AP1000 DESIGN CERTIFICATION REVIEW

Draft Safety Evaluation Report Open Item Response

DSER Open Item Number: 2.3.4-1 Revision 2

Original RAI Number(s): 451.006, 451.006 Rev. 1

Figure 15A-1

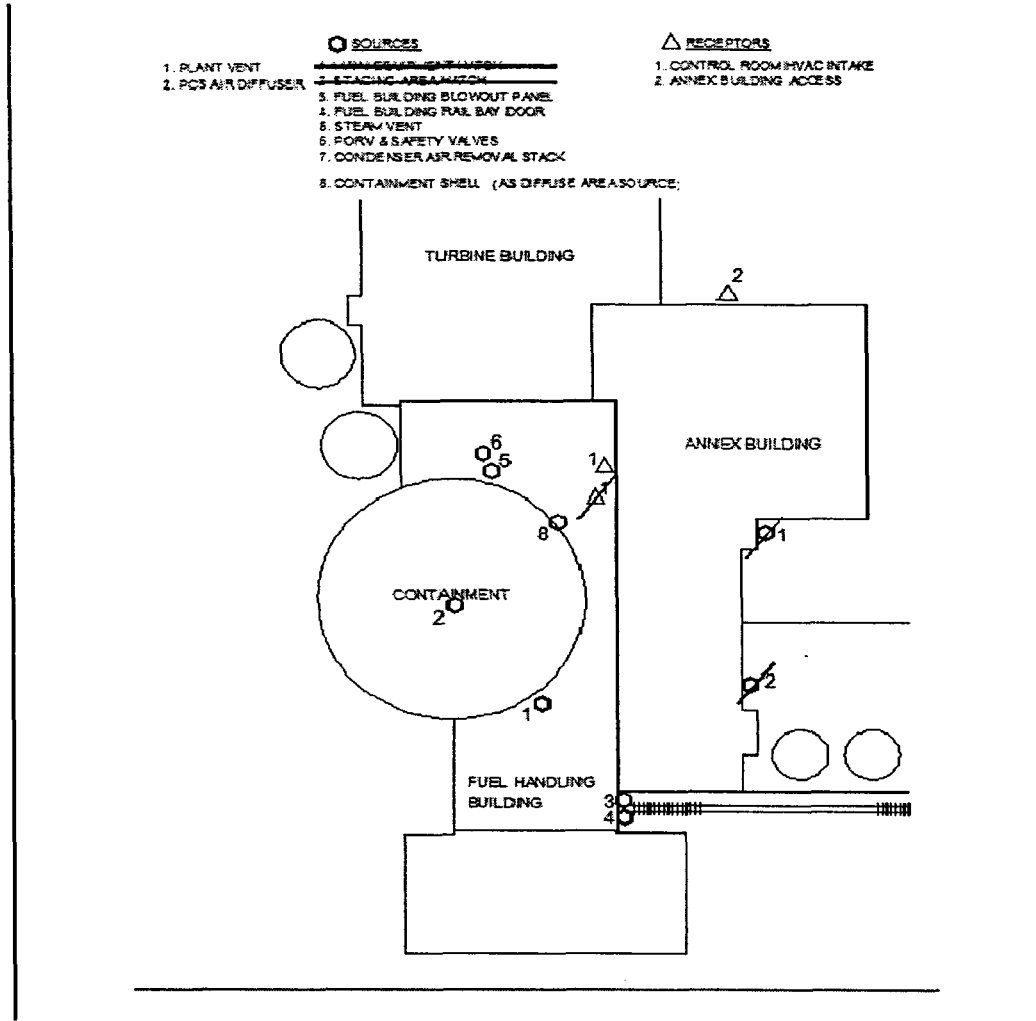
The ARCON96 modeling approach used (as illustrated in attached DCD mark-up, Table 15.A-7 and Figure 15A-1) is fully in compliance with Regulatory Guide 1.194.
